ADDENDUM NO. 0

Date: May 11, 2022

Issued by: Sacramento City Unified School District

Project: **SCUSD Project No. 454-2
Shade Structures Group 1B**

DEMOLITION, GRADING AND PAVING PLAN

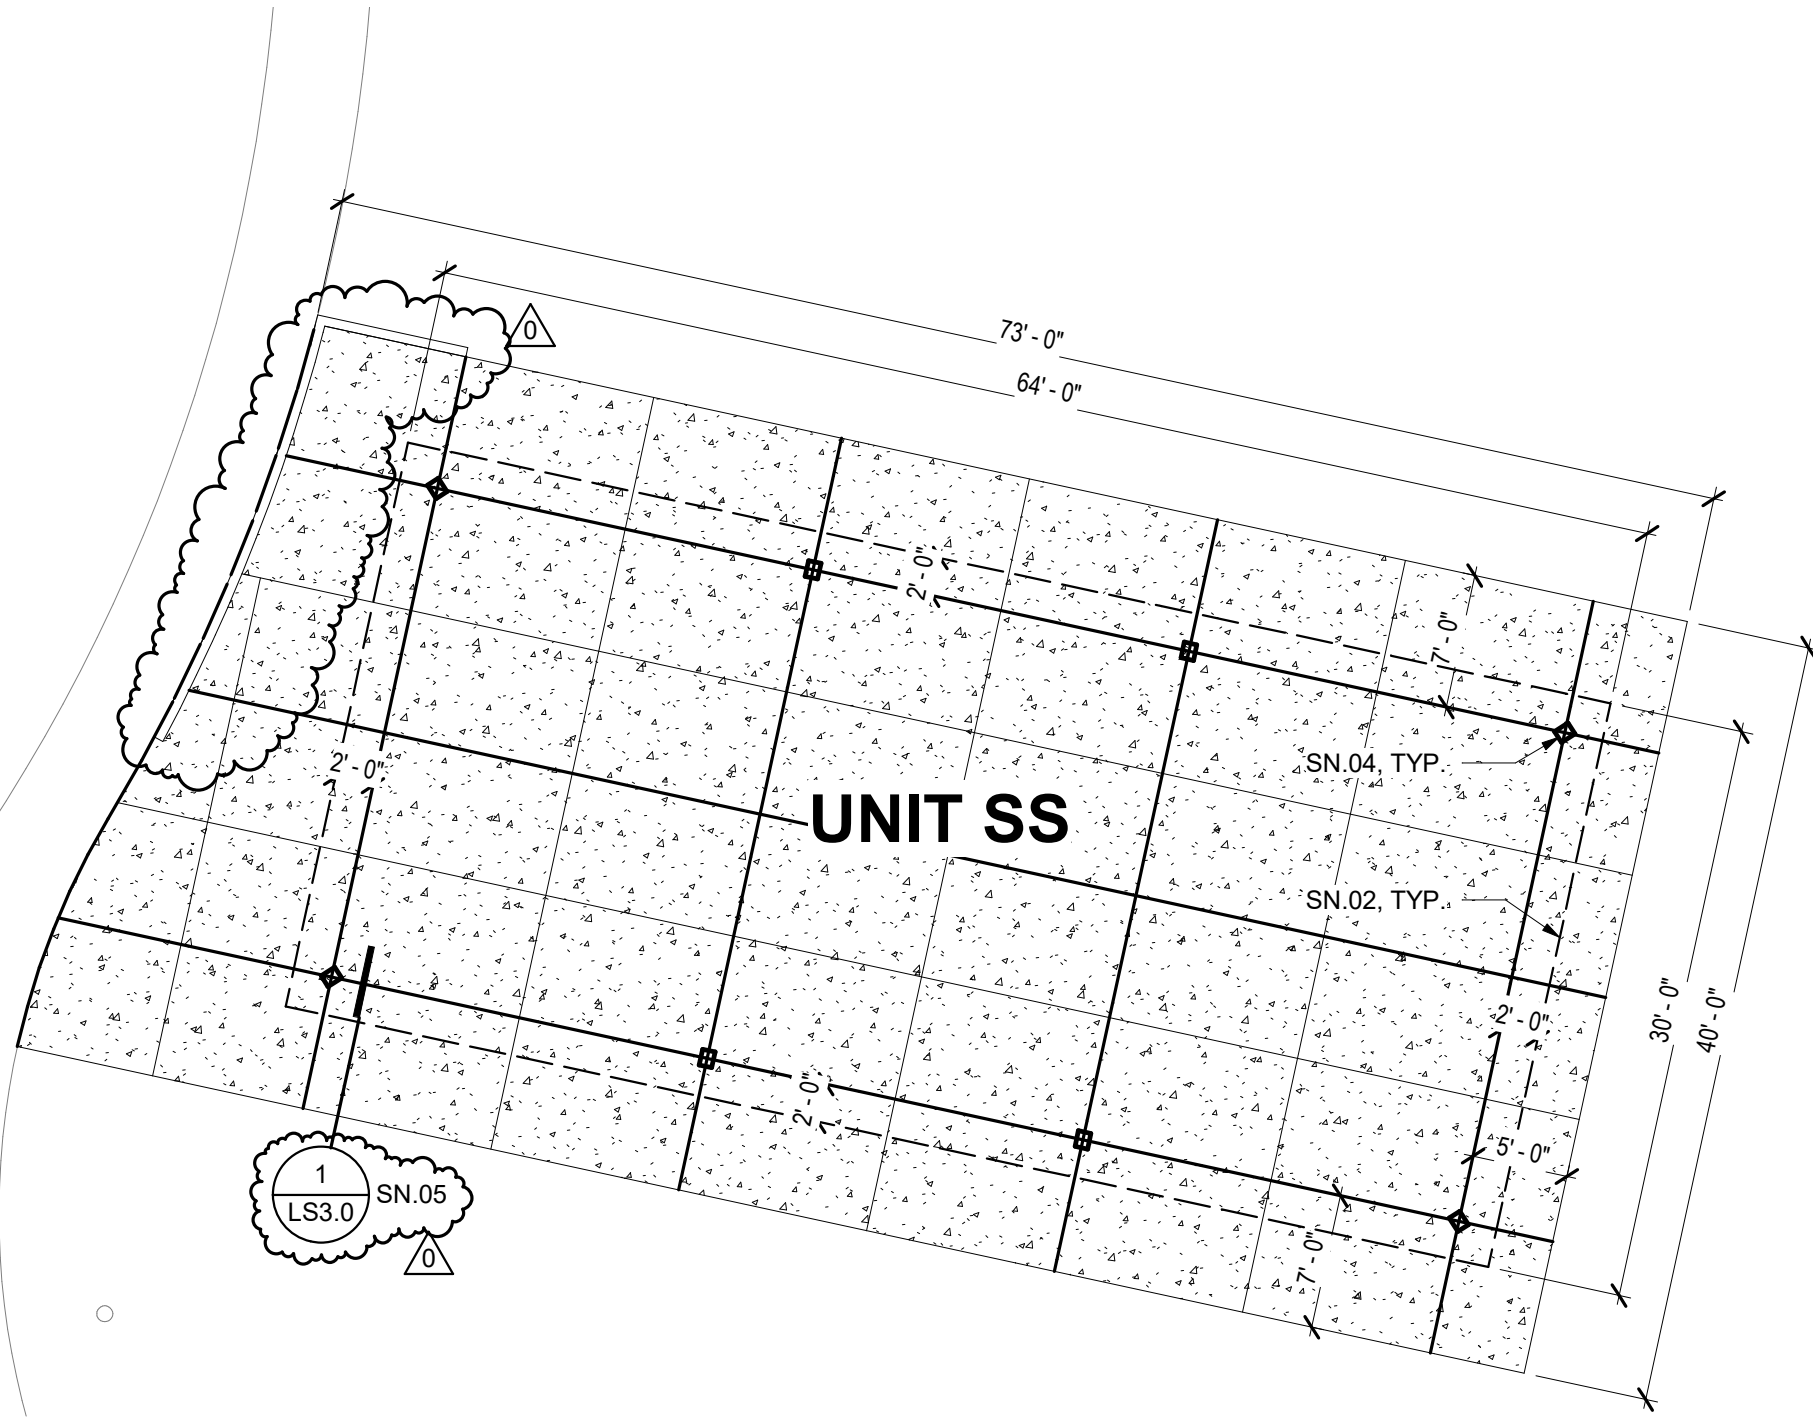
- 3. ADD Landscape / Irrigation Note per sheet AD0.01 included with this addendum.
- C. Sheet C1.1, Demolition, Grading and Paving Plan
 - 1. REVISE existing gas and irrigation line demolition and new scope and all applicable callouts to now include rerouting of these utilities per sheet AD0.02 included with this addendum.

- 2. REVISE planter at Unit SS to curb per sheet AD0.02 included with this addendum.
 - 3. REVISE Grading Notes 16 and 18 per sheet AD0.02 included with this addendum.

- 4. ADD Grading Note 19 per sheet AD0.02 included with this addendum.
 - 5. ADD Demolition Note 5 per sheet AD0.02 included with this addendum.
 - 6. Detail 2, Concrete Curb: REVISE per sheet AD0.02 included with this addendum.

5 TYPICAL STEEL COLUMN & REBAR GROUNDING DETAIL

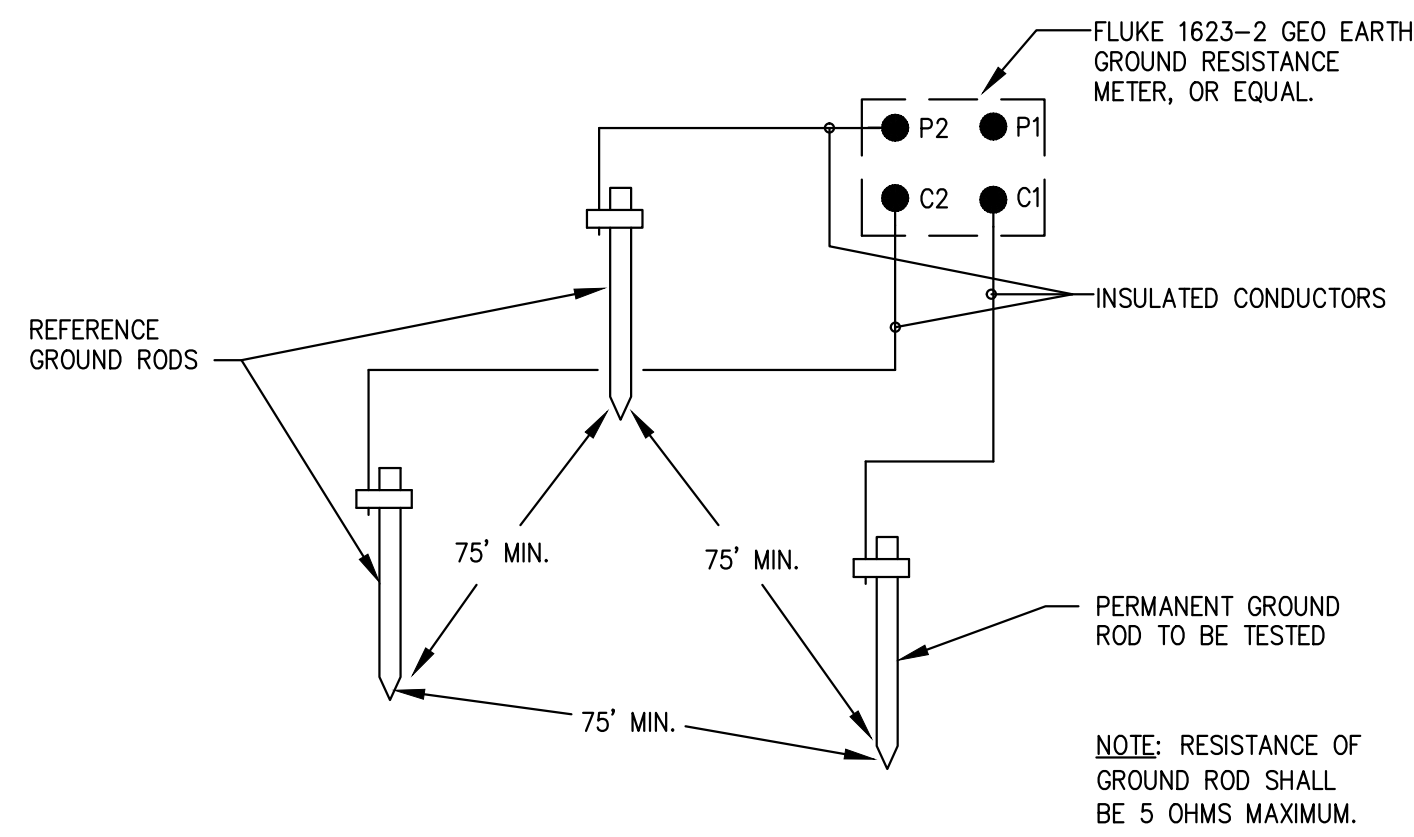
4. Detail 5, Typical Steel Column & Rebar Grounding Detail: REVISE per sheet AD0.05 included with this addendum.
- H. Sheet 2, Statement of General Conformance

2 TYPICAL H/20 TRAFFIC RATED PULL BOX

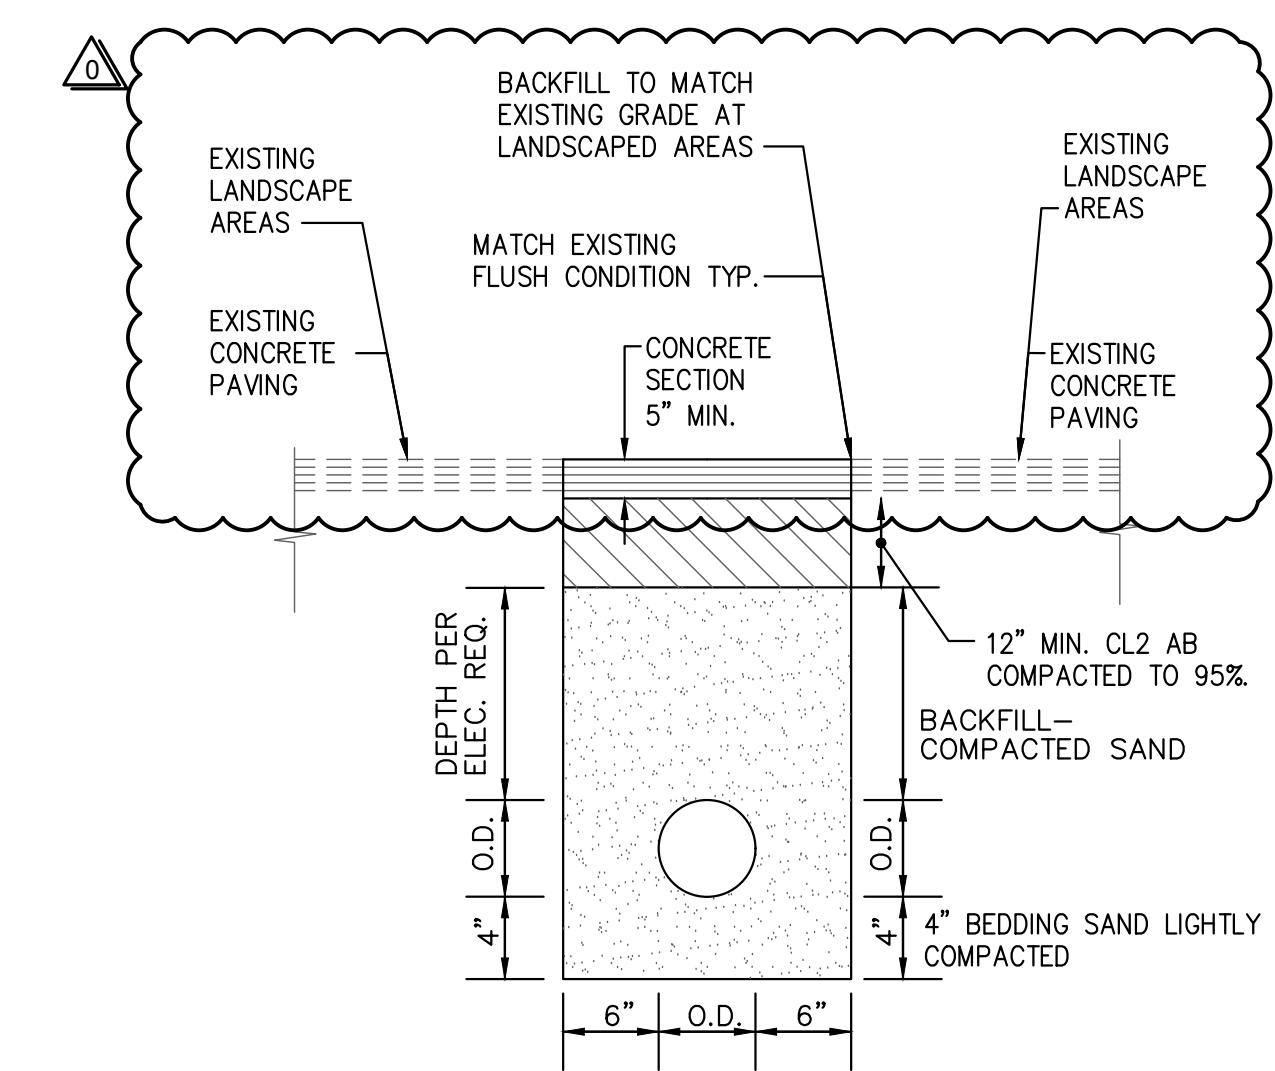
3. ADD Keyed Notes 6 and 7 per sheet AD0.04 included with this addendum.
- G. Sheet E3.1, Details
1. Detail 2, Typical H/20 Traffic Rated Pull Box: REVISE per sheet AD0.05 included with this addendum.

ENLARGED PLAN	A1.1.1	DATE: 04/29/22
SHADE STRUCTURE AT JOHN BIDWELL ELEMENTARY SCHOOL SACRAMENTO CITY UNIFIED SCHOOL DISTRICT SACRAMENTO, CA DSA APP.02-119979		
PROJECT NO.: 21-1504.02	SHEET: AD0.02

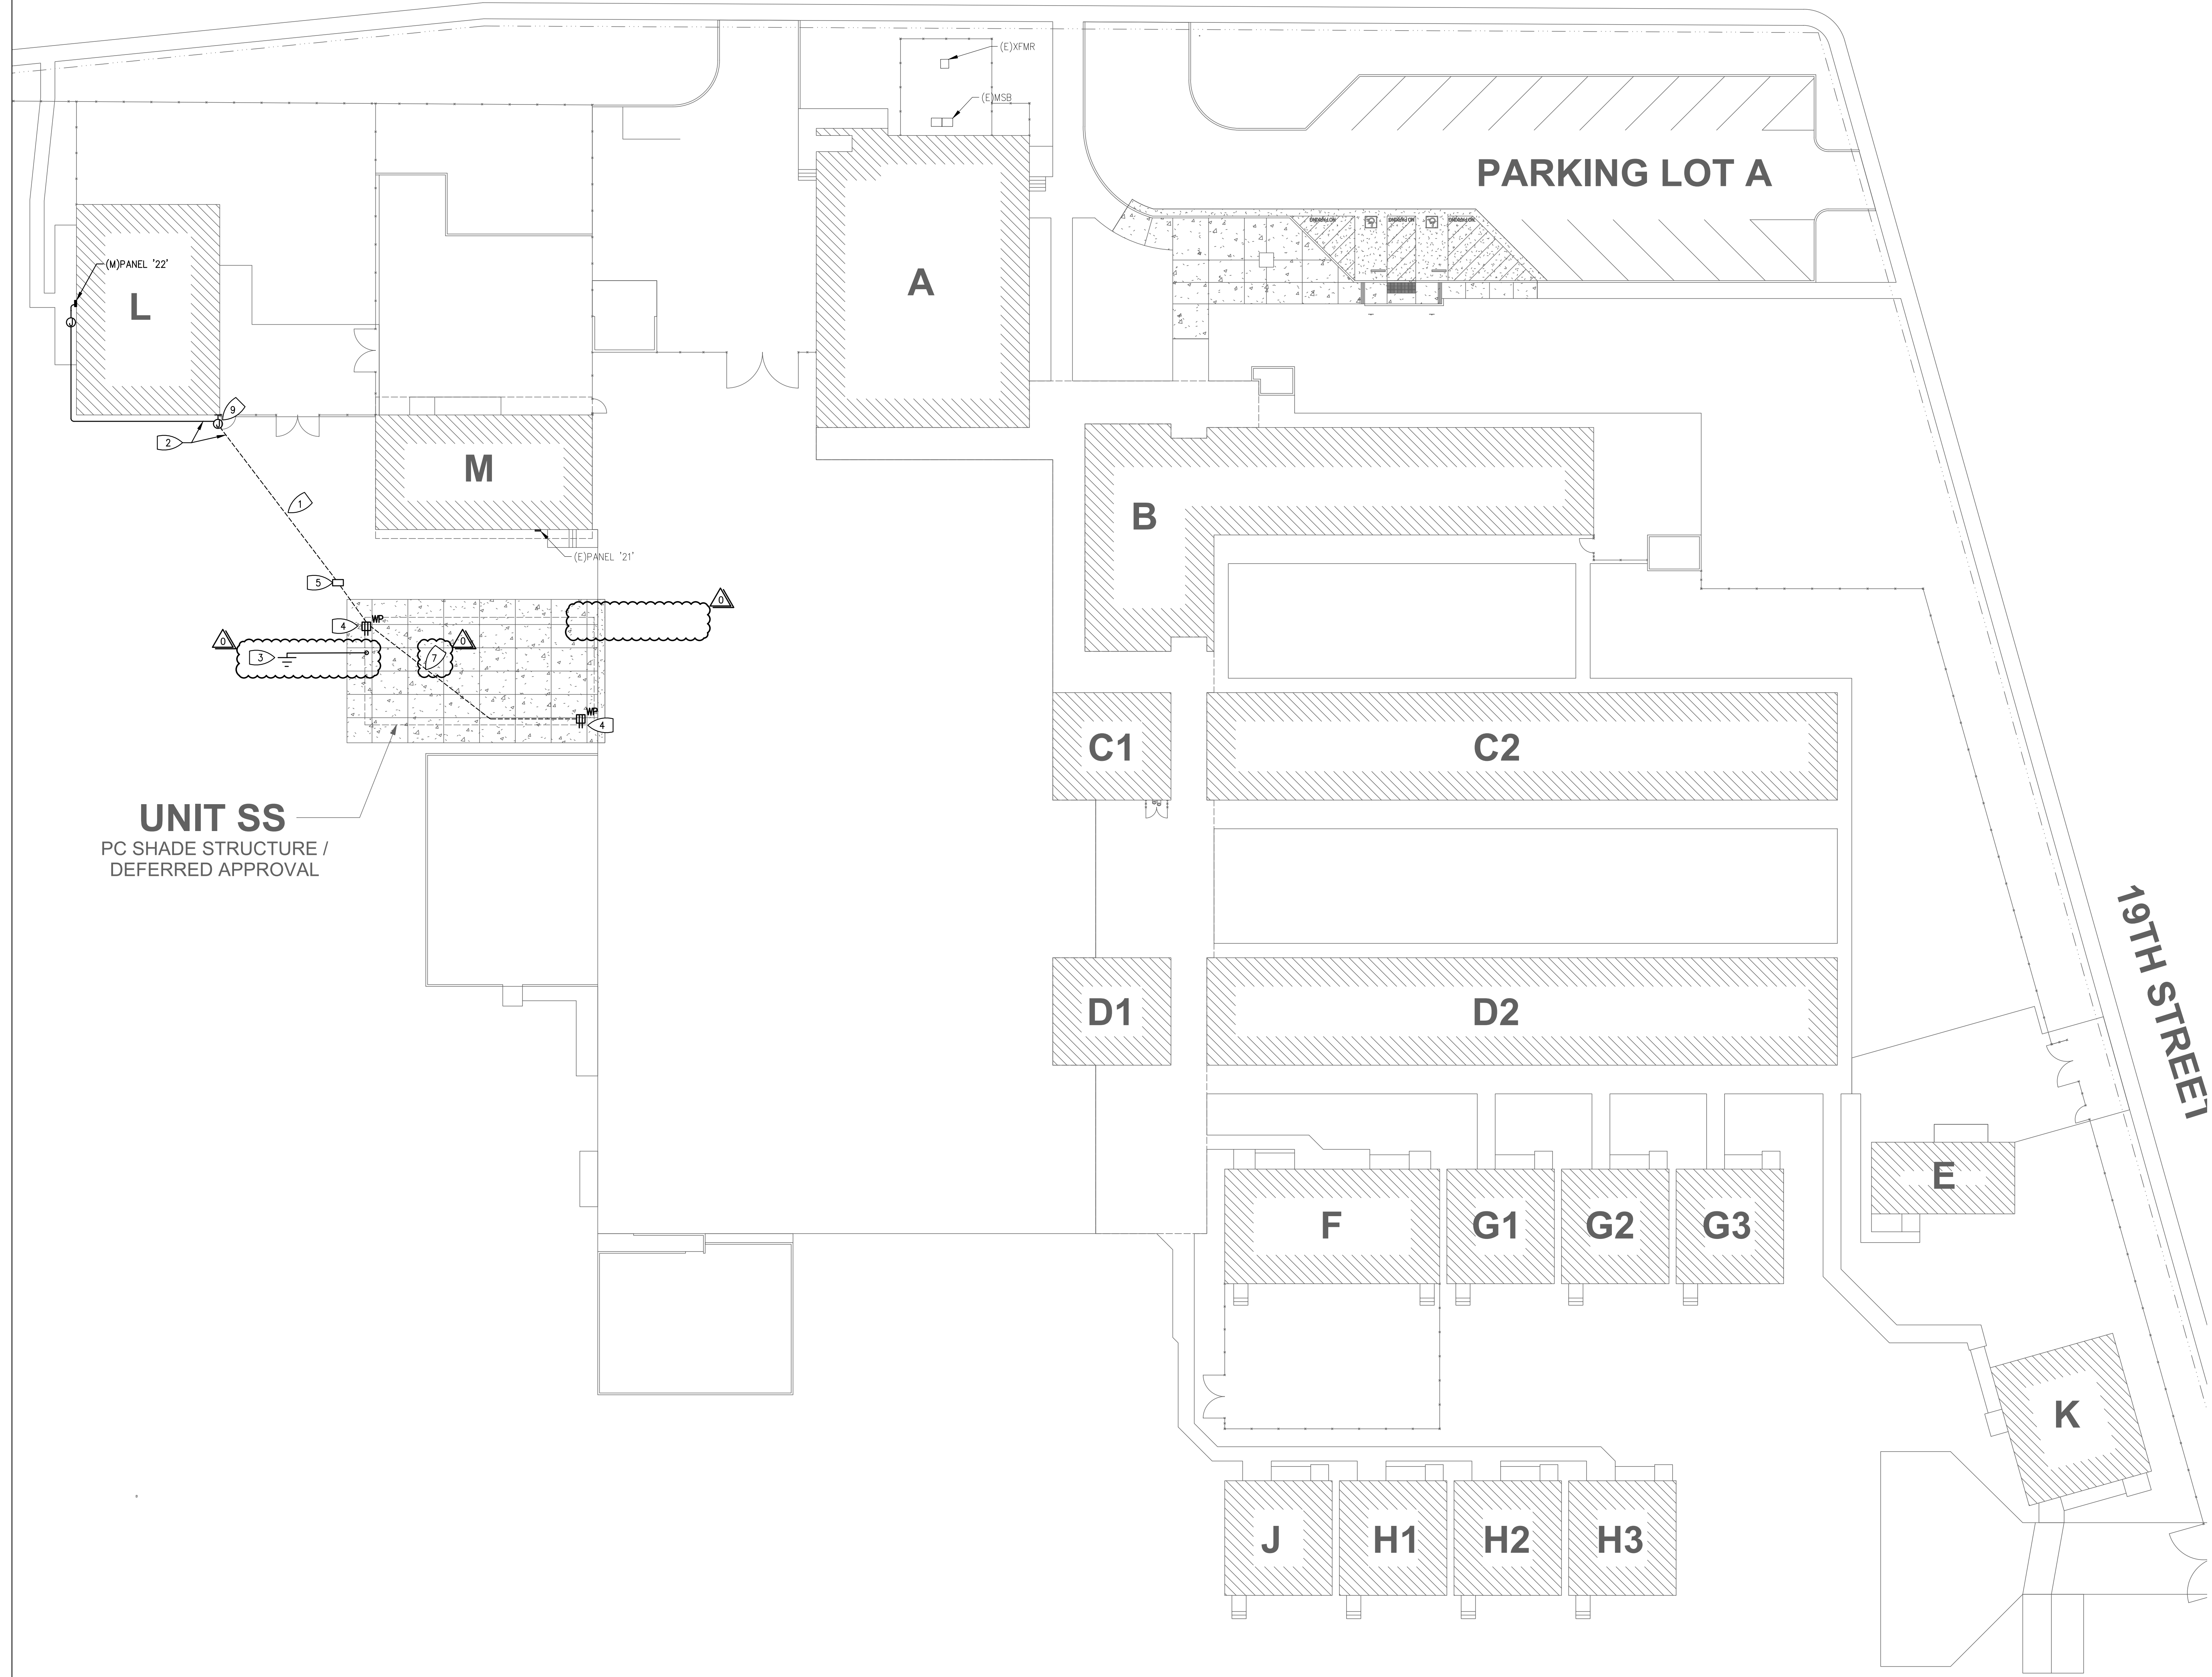
4. Detail 2, Enlarged Site Plan – Shade Structure: REVISE site plan to now show a section callout at the shade structure column per sheet AD0.02 included with this addendum.

5. Sheet Note 4: ADD note. Text to read “For footing / concrete pad / column interaction, see PC shade structure / deferred approval”
- C. Sheet E1.1, Site Plan - Electrical
